BOARD ACTION REPORT – APPEALABLE ITEM

Project Name: Delray Square
Project Location: 4979 W. Atlantic Avenue
Request: Approval of a Class I Site Plan modification
Board: Site Plan Review and Appearance Board
Meeting Date: April 25, 2018

---STAFF REPORT---

ITEM: **Delray Square (2018 – 062):** The item before the Board is the approval of a Class I Site Plan Modification associated with minor changes to building elevations located on Building "D" at Delray Square located at 4979 W. Atlantic Avenue

PROPOSED RETAIL BUILDING FACADE MODIFICATION

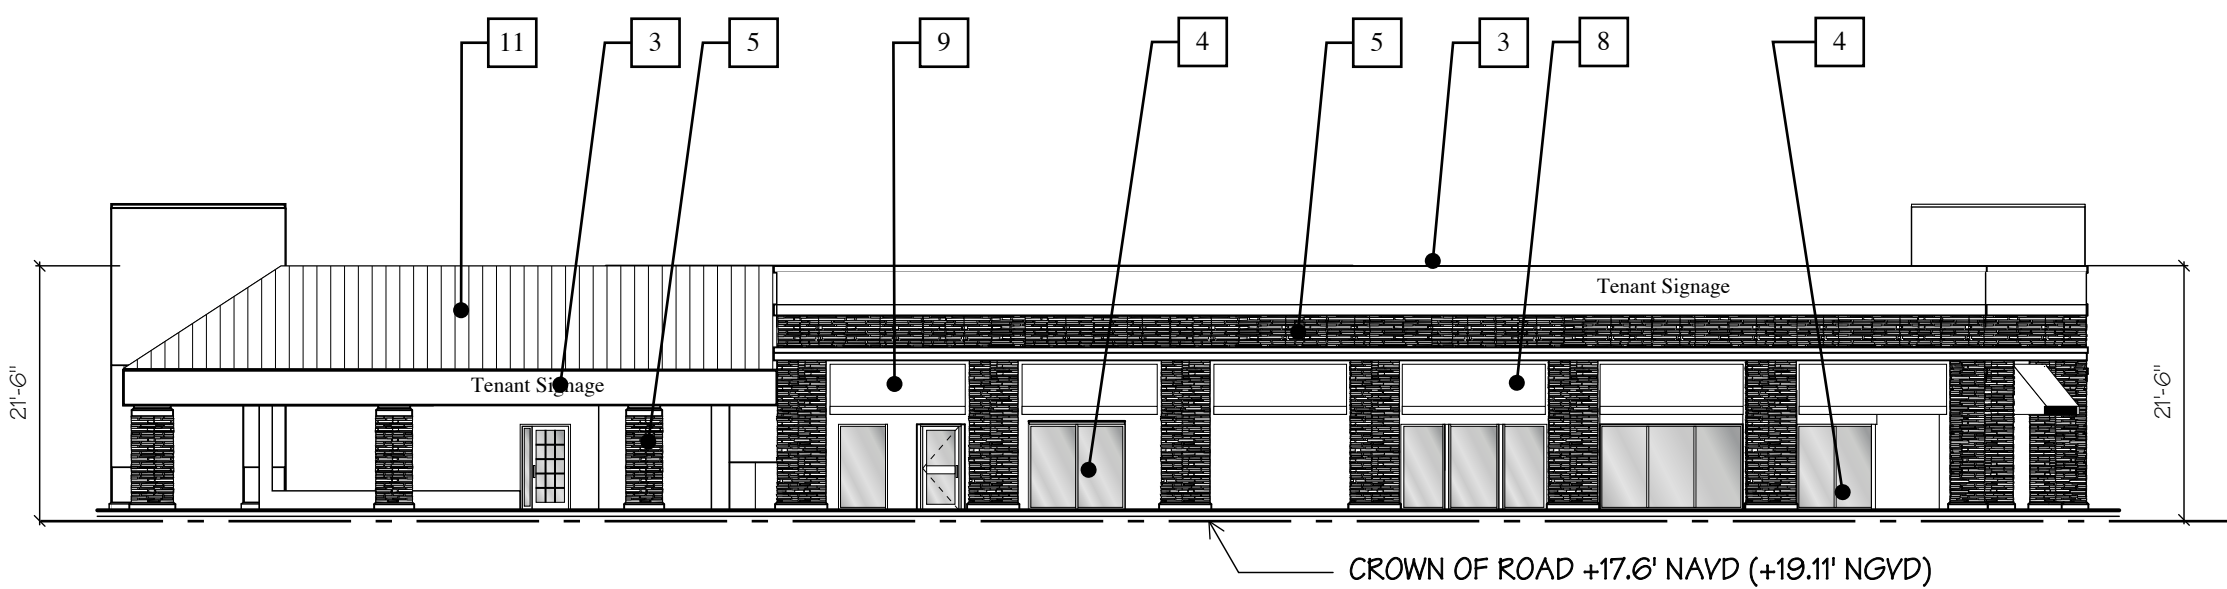
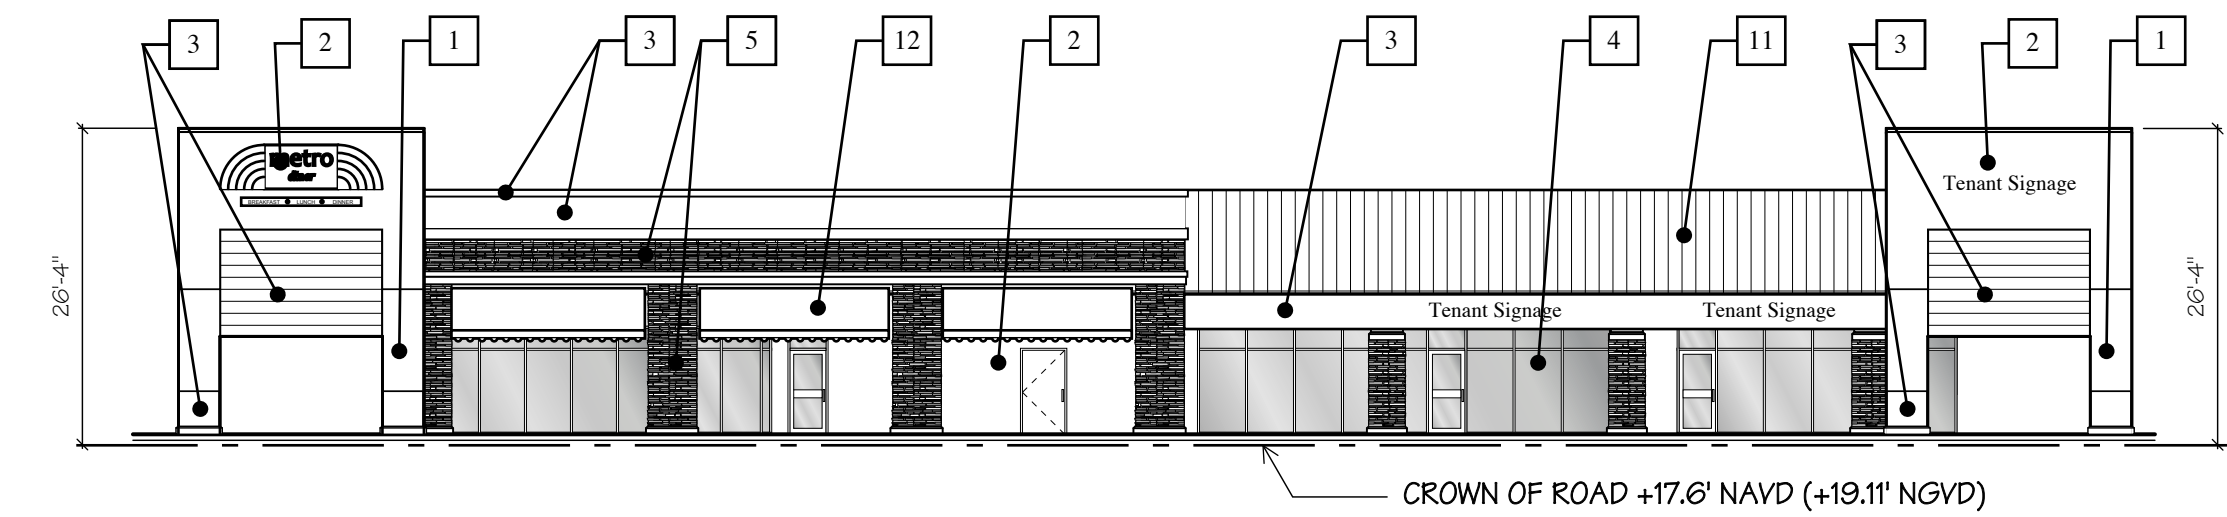
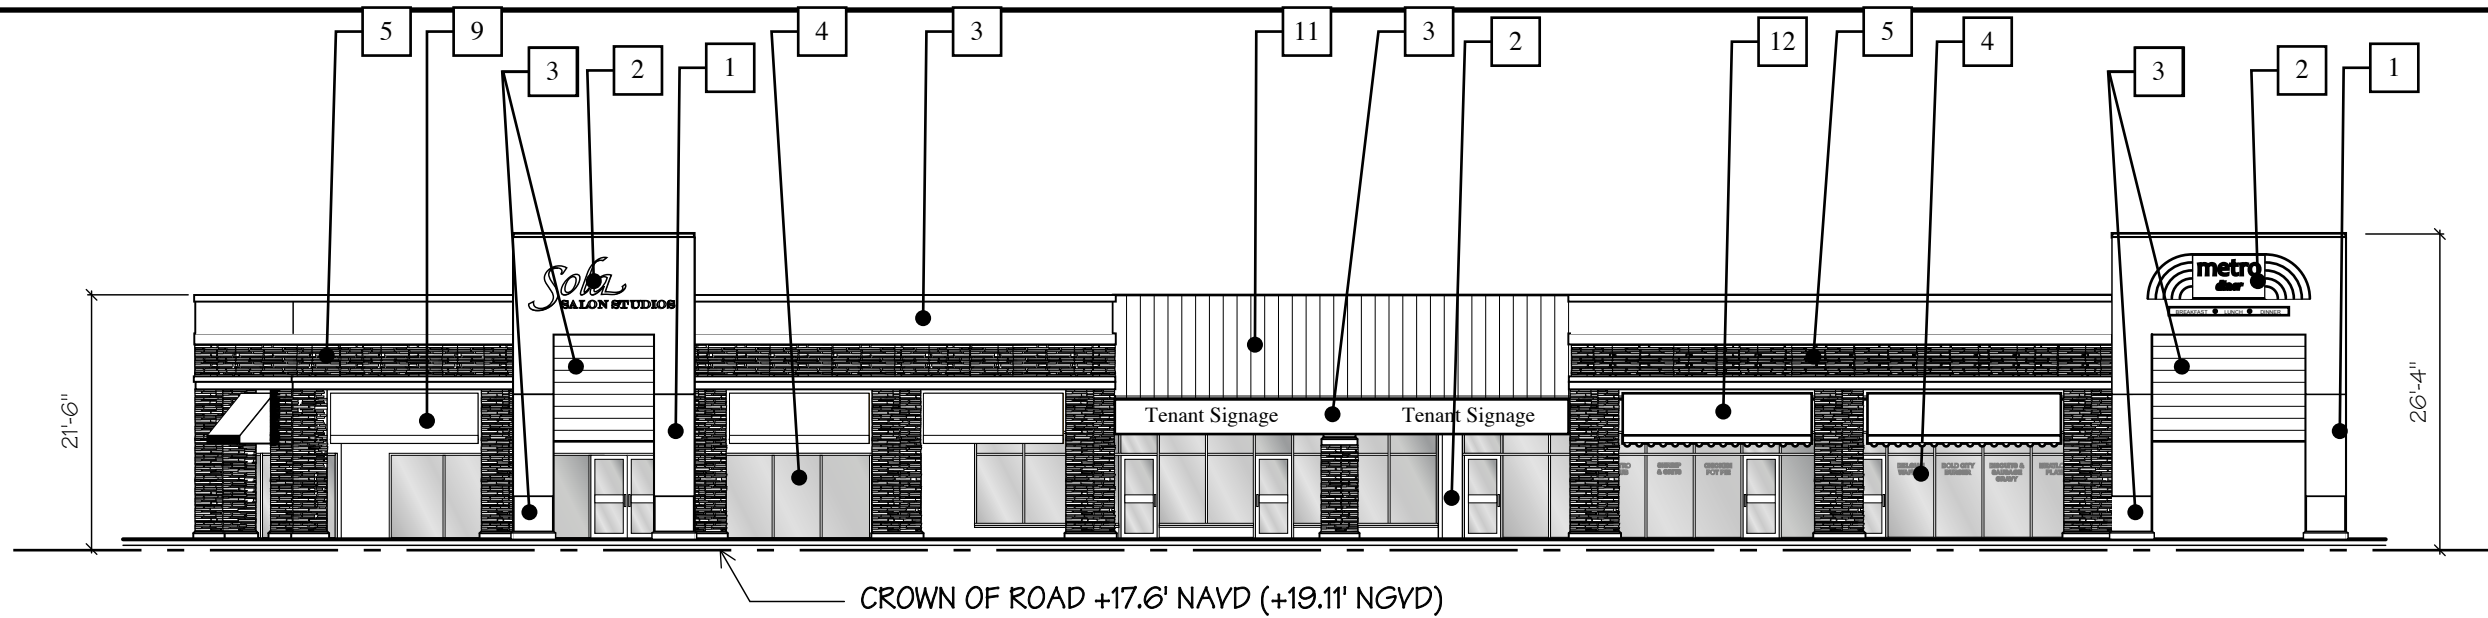
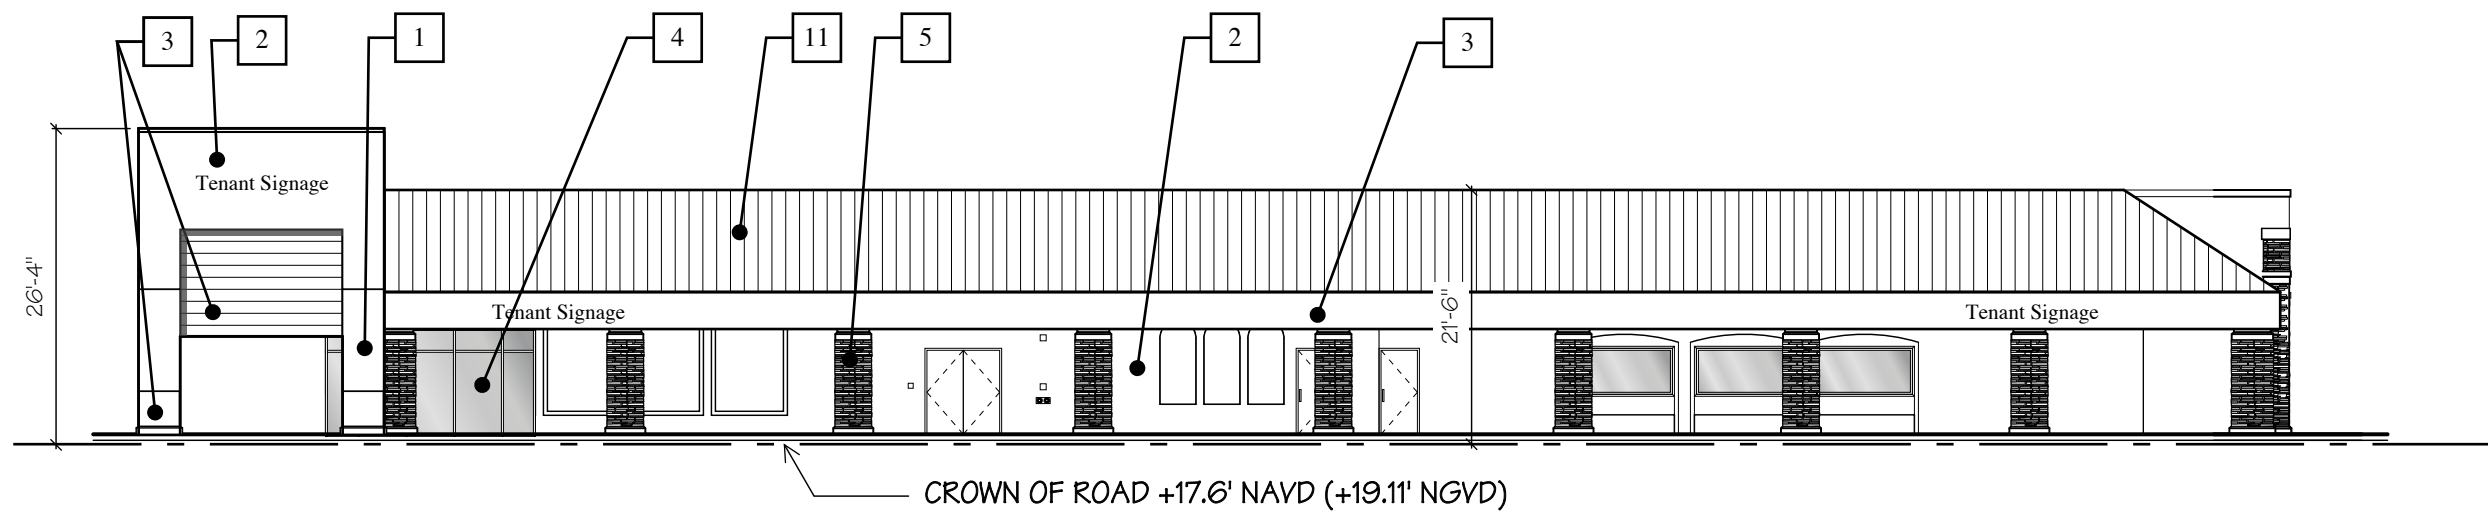
The applicant is proposing changes to all of the elevations to Building “D” of Delray Square. The removal of standing seam metal copperclad façade and replacing it with a white metal eifs and cultured stone in a country ledgestone in a caramel color and the addition of bronzed anodized windows is proposed on the east, west, and south elevation. On the east façade, charcoal awnings are being introduced that will cantilever 3’2”. In addition, the south façade is introducing forest green awnings that will also cantilever 3’2”. A new parapet is being introduced on the south façade. The stucco will be painted a light and medium beige.

The proposed elevation change is in harmony with the rest of the shopping plaza and will be an asset to Delray Square. The changes are interior to the property and will not materially depreciate or adversely affect the neighboring areas. Based upon the above positive findings can be made with respect to LDR Section 4.6.18 (E).
